**MASTER DEVELOPMENT  
DRAINAGE PLAN  
FOR  
ESTEBAN RODRIGUEZ SUBDIVISION SKETCH PLAN,  
EL PASO COUNTY, COLORADO**

February 2024

PCD File No.: SKP237

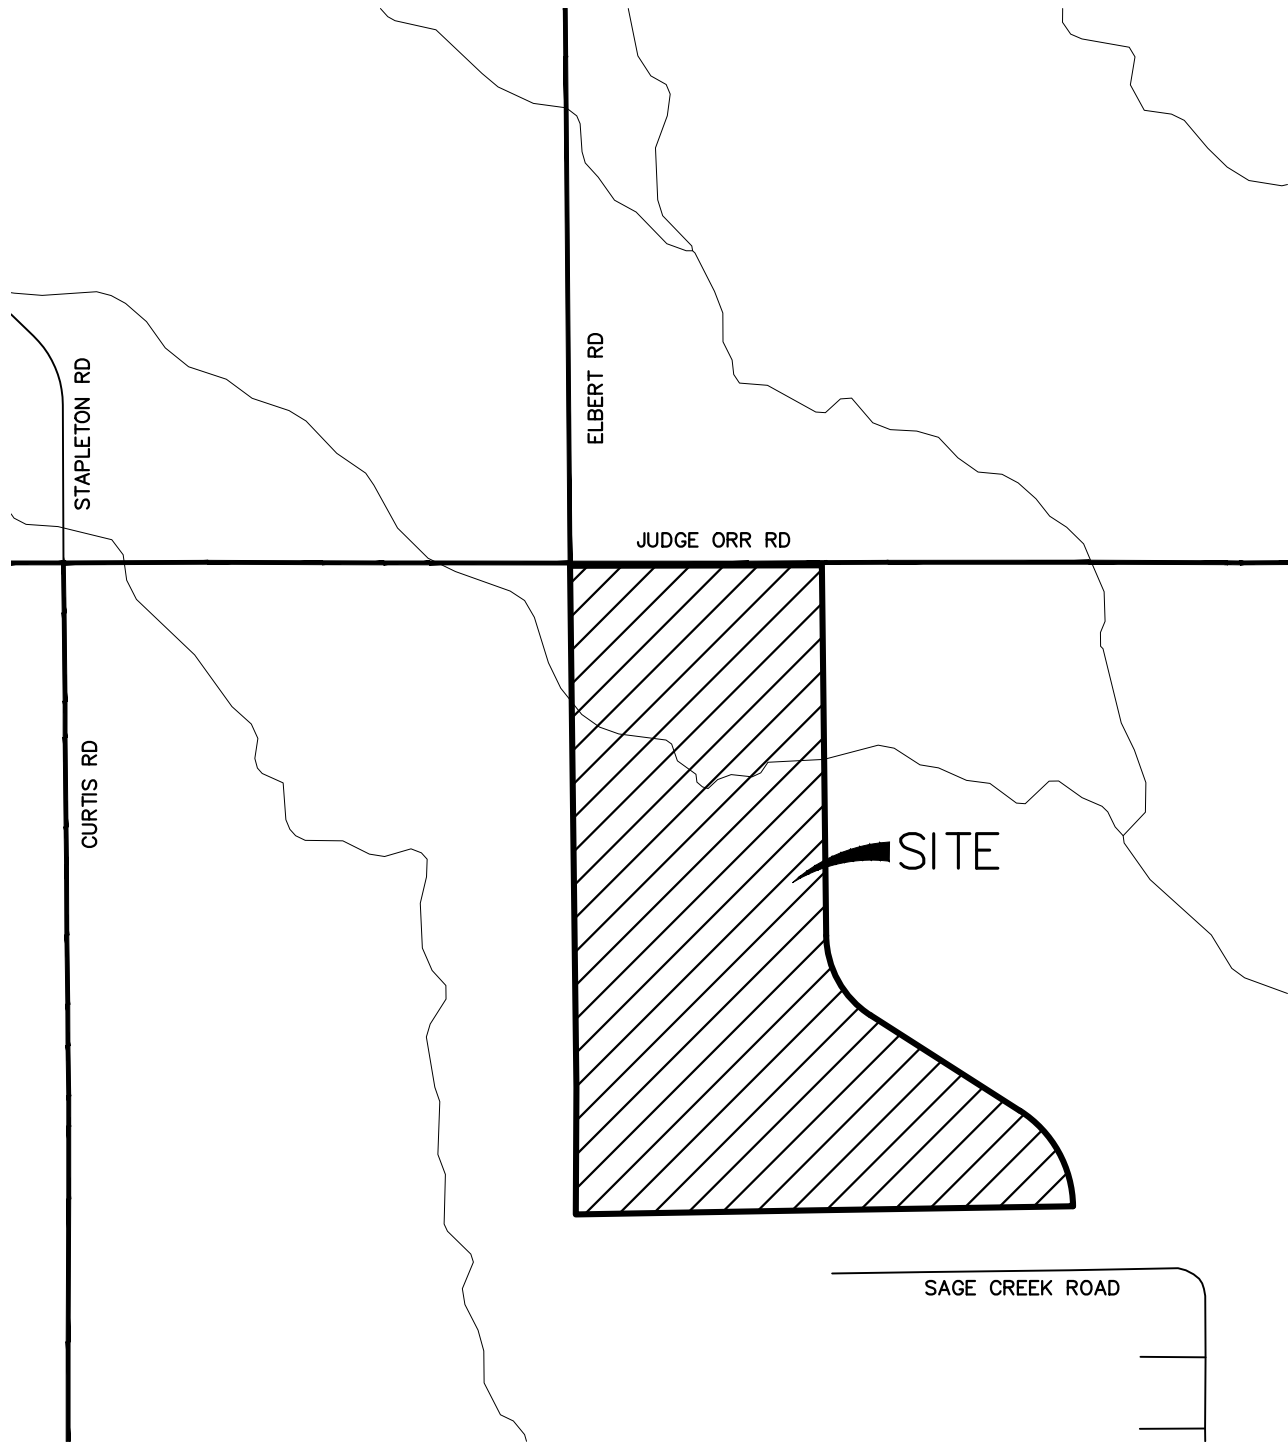
Review 1: Although indicated that flows will be released at less than historic, they are also concentrated instead of historic sheet flow conditions. Please discuss and analyze the downstream conditions of each of the outfall points (see DCMV1 Ch4.2).  
Review 2: unresolved.

Review 1 comment:  
Provide preliminary analysis of the channel and identify anticipated infrastructure needed at the road crossings and any other improvements needed to stabilize the channel.  
Review 2: unresolved. Please provide a preliminary analysis of the channel and identify issues, stabilization design, anticipated infrastructure needed at the road crossings etc.
